RHODE ISLAND DEPARTMENT OF TRANSPORTATION

RHODE ISLAND CONTRACT NO.2016-CH-055

Pedestrian and Intersection Safety Improvements w/ Albion Beacon - STC

ADDENDUM NO. 1 Prospective bidders and all concerned are hereby notified of the following changes in the Plans, Specifications, Proposal and Distribution of Quantities for this contract. These changes shall be incorporated in the Plans, Specifications, Proposal and Distribution of Quantities, and shall become an integral part of the Contract Documents.

GENERAL AND LOCATION PLAN NO.2
BOSTON NECK ROAD AT METTATUXET ROAD
NARRAGANSETT RHODE ISLAND

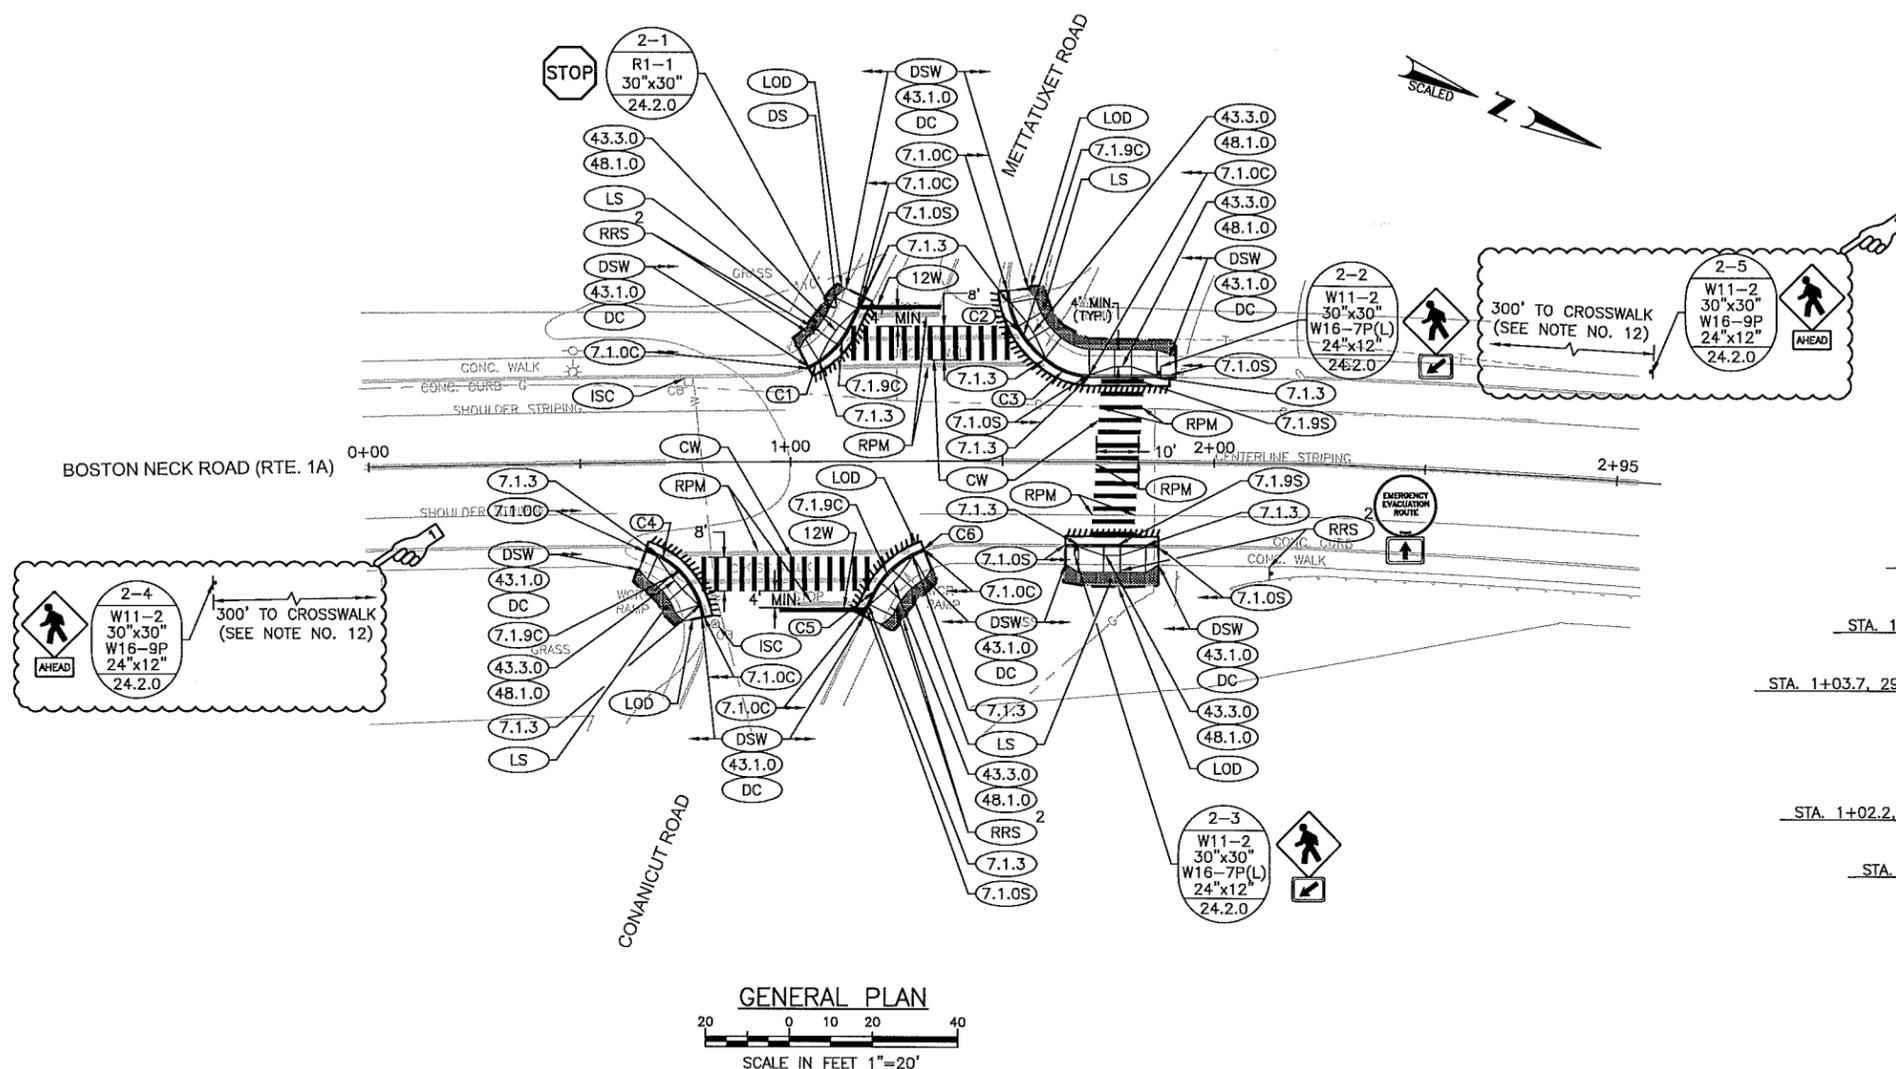
Delete Sheet No. 11 – General and Location Plan No. 2 in its entirety and replace it with Sheet No. 11 – General and Location Plan No. 2 (R-1) attached to this Addendum No. 1. Signs and callouts have been added.

| REVISIONS | | | RHODE ISLAND DEPARTMENT OF TRANSPORTATION | |
|-----------|---------|-----|--|--|
| | | | GENERAL AND LOCATION PLAN NO.4 | |

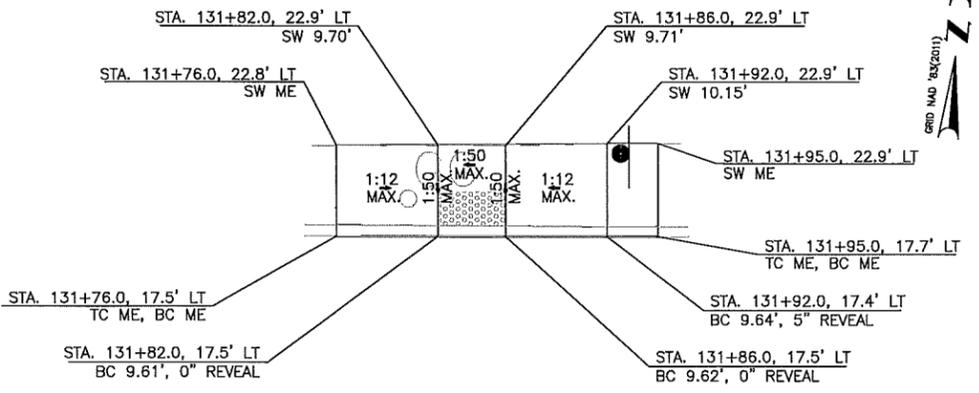
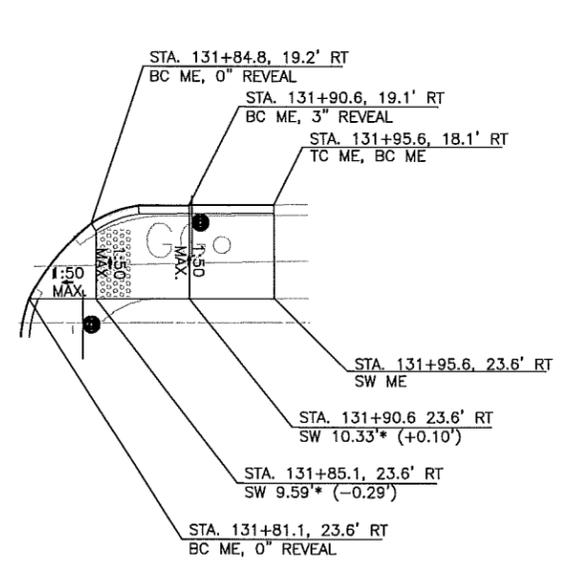
Delete Sheet No. 13 – General and Location Plan No. 4 in its entirety and replace it with Sheet No. 13 – General and Location Plan No. 4 (R-1) attached to this Addendum No. 1. Signs and callouts have been added. General Note No. 10 has been revised.

TRAFFIC SIGNAL PLAN NO.1

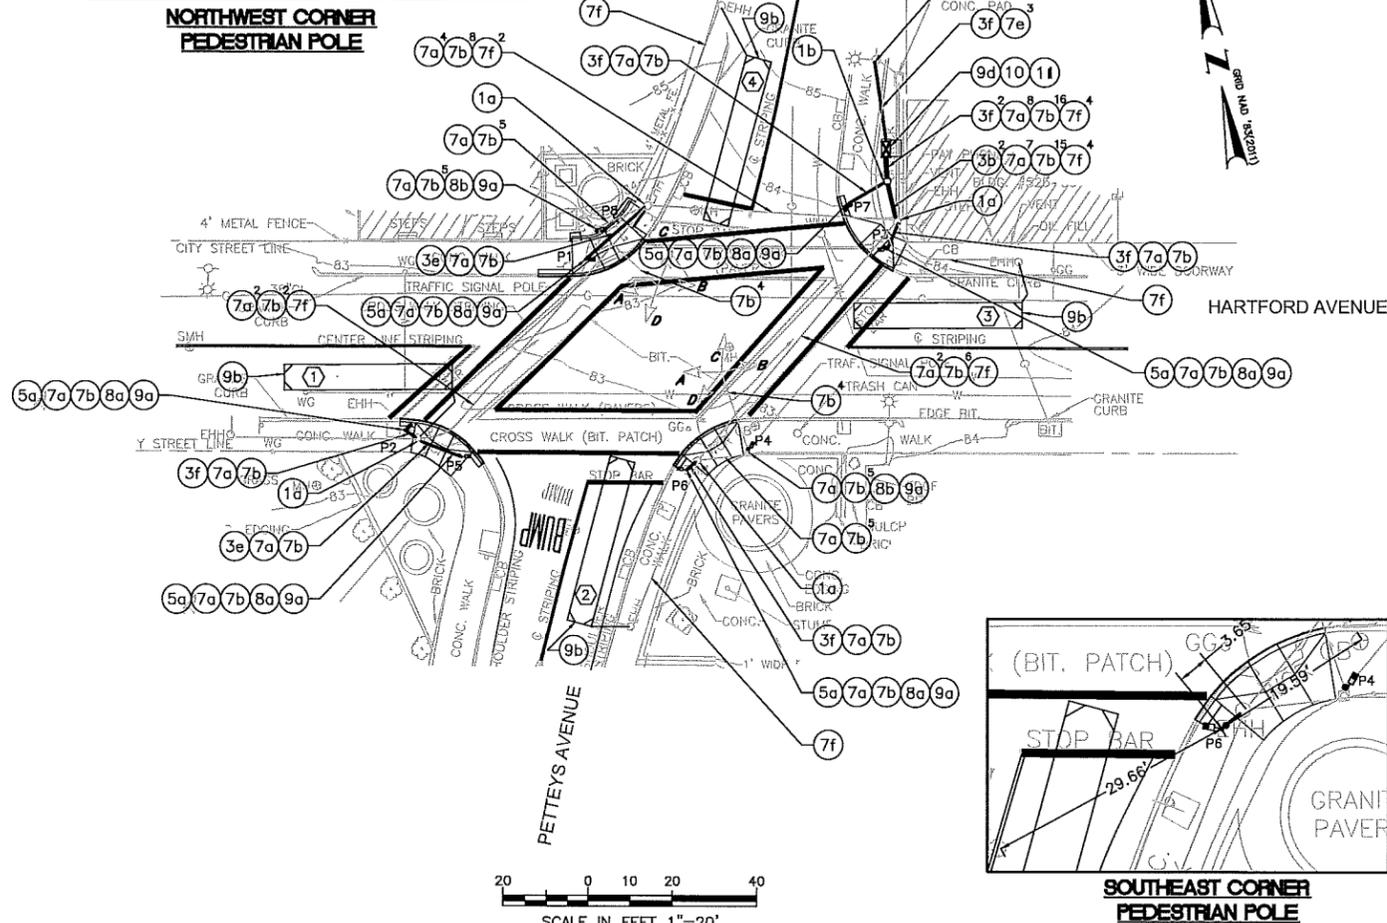
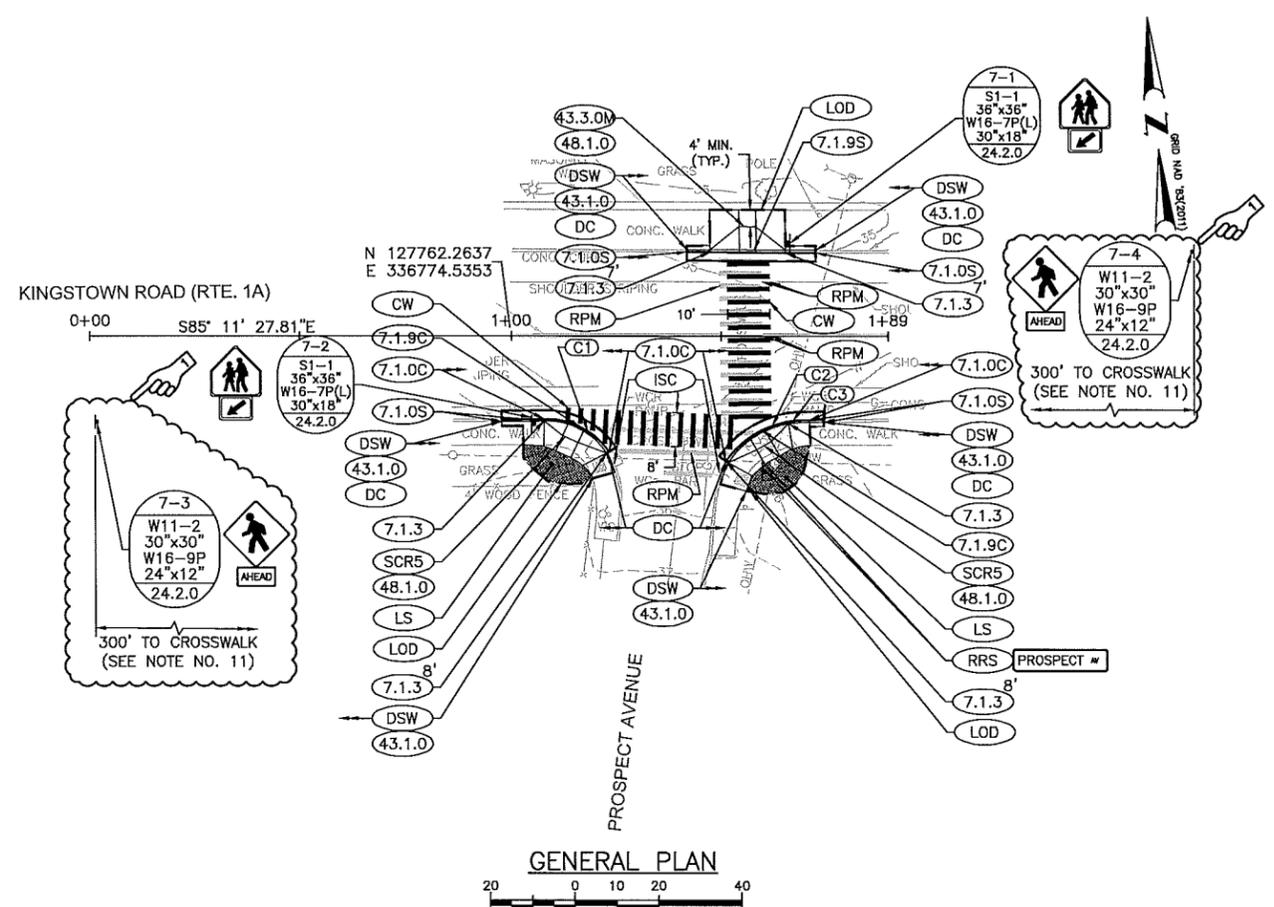
Delete Sheet No. 16 – Traffic Signal Plan No. 1 in its entirety and replace it with Sheet No. 16 – Traffic Signal Plan No. 1 (R-1) attached to this Addendum No. 1. The Sequence and Timing Diagram has been updated.

GENERAL AND LOCATION PLAN NO.7
KINGSTOWN ROAD AT SPRAGUE PARK
NARRAGANSETT RHODE ISLAND

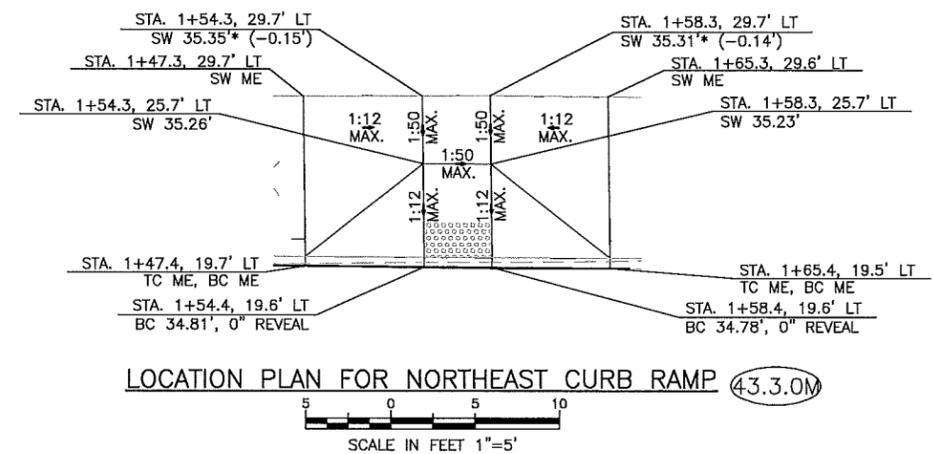
Delete Sheet No. 17 – General and Location Plan No. 7 in its entirety and replace it with Sheet No. 17 – General and Location Plan No. 7 (R-1) attached to this Addendum No. 1. Signs and callouts have been added.

TRAFFIC SIGNAL PLAN NO.2
 WARWICK AVENUE AT CHURCH AVENUE
 WARWICK RHODE ISLAND

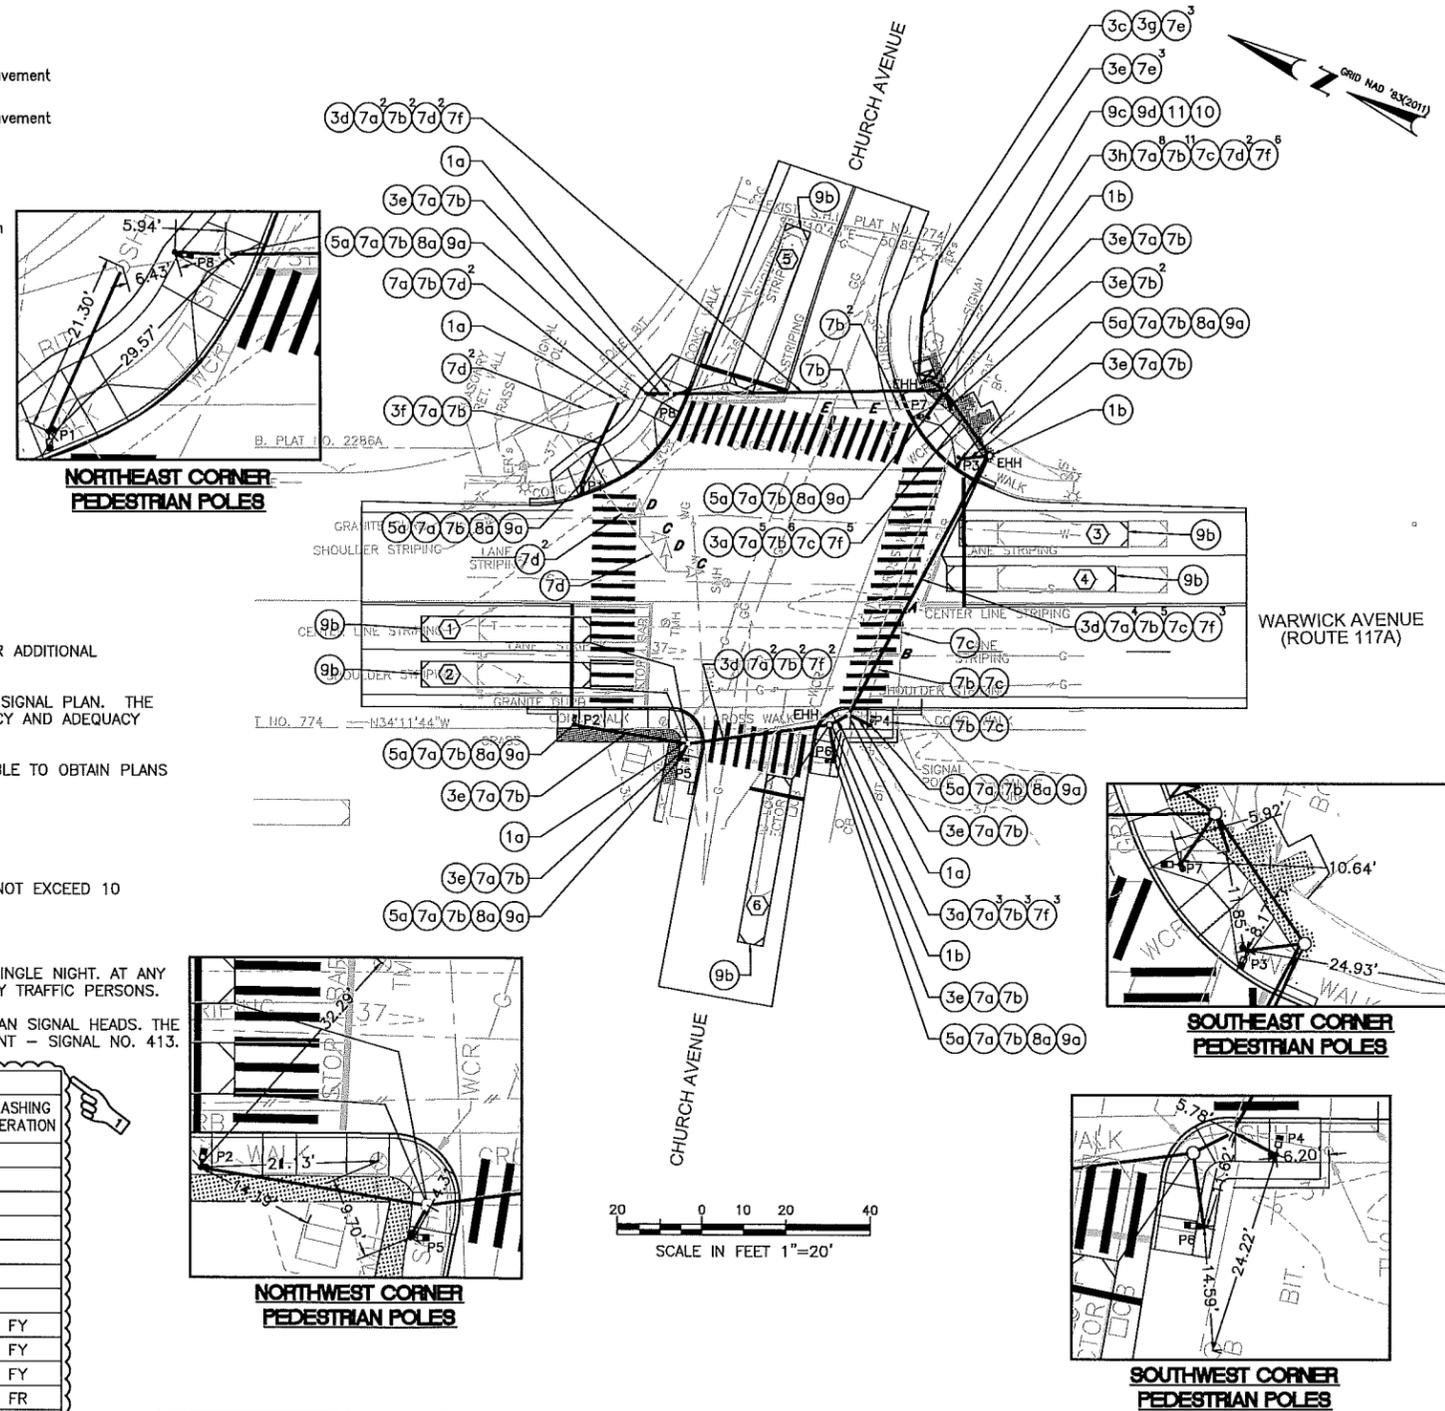
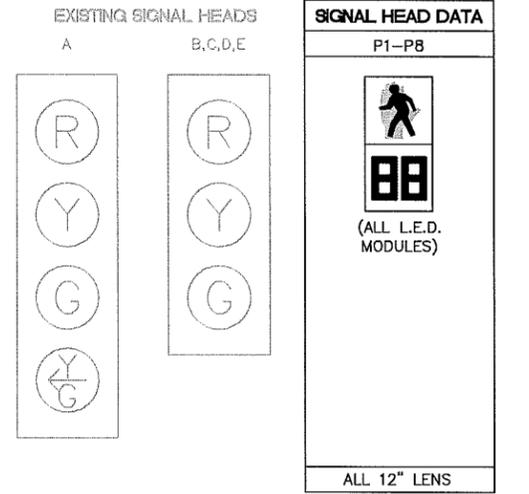
Delete Sheet No. 27 – Traffic Signal Plan No. 2 in its entirety and replace it with Sheet No. 27 – Traffic Signal Plan No. 2 (R-1) attached to this Addendum No. 1. The Sequence and Timing Diagram has been updated.
